**CITY OF BATON ROUGE
PARISH OF EAST BATON ROUGE
DEPARTMENT OF ENVIRONMENTAL SERVICES**

ADDENDUM NO. 1

SUBJECT: **JOOR ROAD / GREENWELL SPRINGS ROAD SEWER AREA UPGRADES
CITY-PARISH PROJECT NO. 11-FM-MS-0023**

GRAVITY SEWER CONNECTION TO PUMP STATION 128
SCALE: N.T.S.

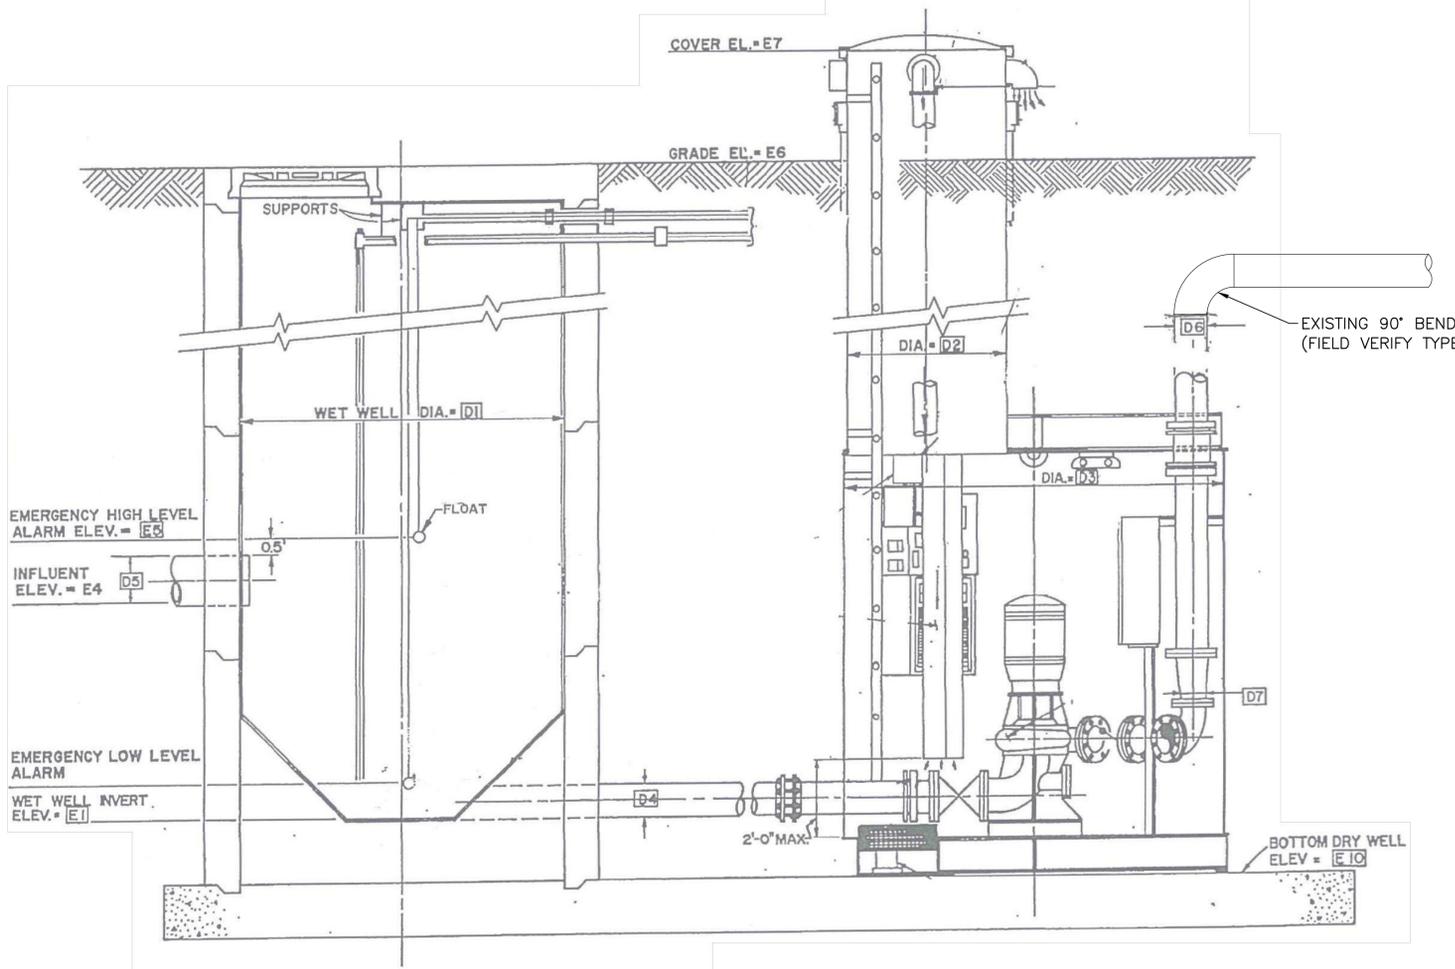
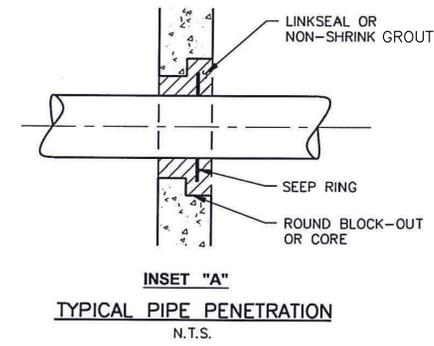
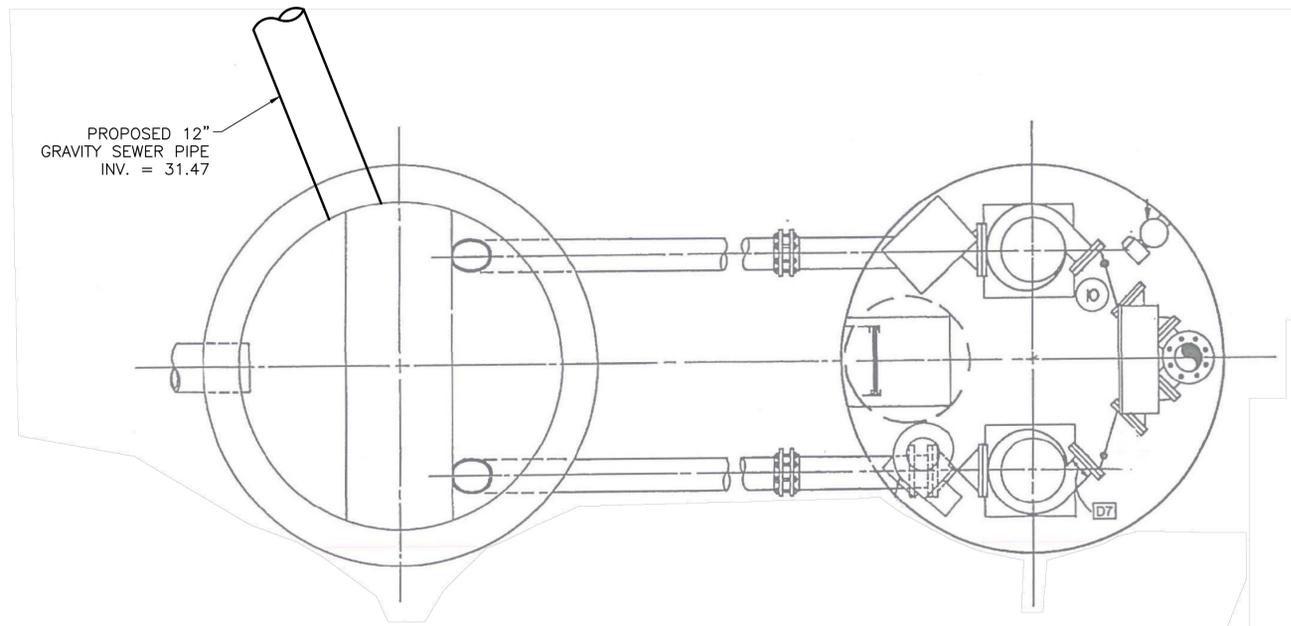
3. There is a required wet well tie-in (PS 128). Does this wet well have a T-Lock liner?

This wet well is not expected to have a T-Lock liner.
